<b>Company</b>	Trenz Electronic GmbH
<b>PCN Number</b>	PCN-20200818
<b>Title</b>	KK0807-02 to KK0807-02A Hardware Revision Change
<b>Subject</b>	Hardware Revision Change
<b>Issue Date</b>	2020-10-02

<b>Affected Product</b>	<b>Replacement</b>
KK0807-02	KK0807-02A

### 2.1 #1 Added four M3 mountig holes.

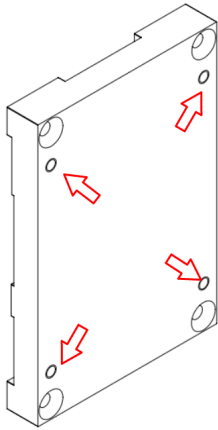
**Type:** Hardware change

**Reason:** Request for screwed mounting of cooler on heatspreader.

**Impact:** The heatspreader is compatible with cooler KK0001-01.

Models with 4 additional threads are revision 02A.
